Input polarity markings for KMD-5220

Issued 22 February 2011

This service bulletin applies only to model KMD-5220.

Illustration 1 KMD-5220 polarity markings

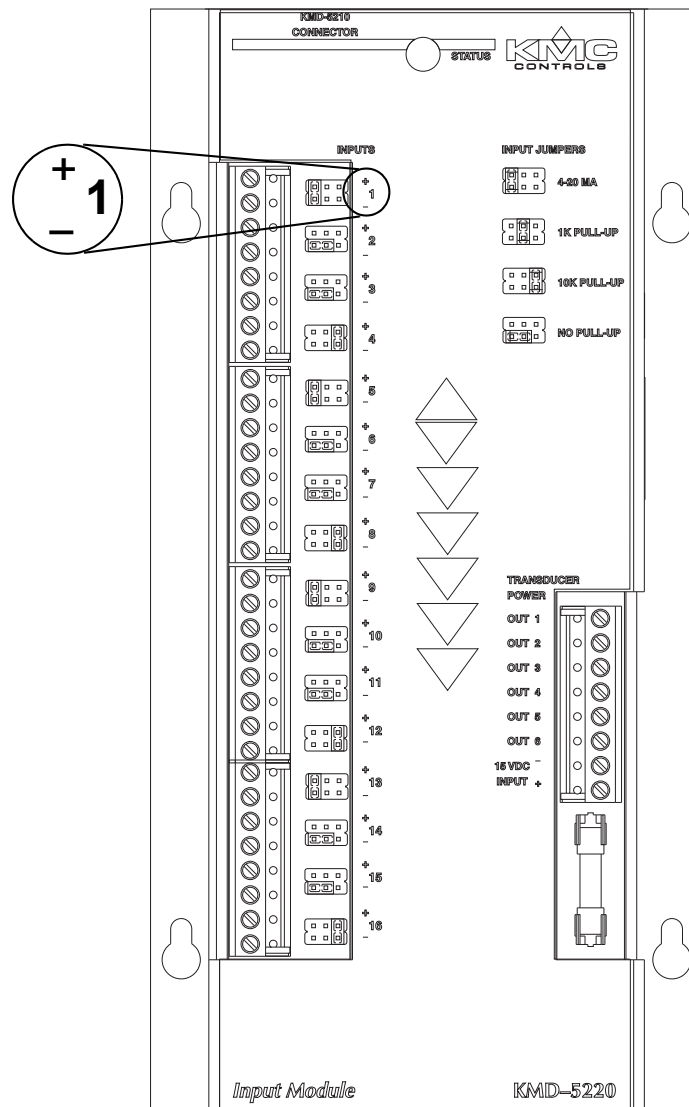
In late 2010, the input polarity markings on the label for model KMD-5220 were erroneously reversed. The correct polarity is shown in the illustration *KMD-5220 polarity markings*. The polarity markings on the circuit board are correct. Also, the illustrations in the installation and operation guide supplied with the KMD-5220 are correct. It is anticipated this problem will be corrected in the first quarter of 2011.
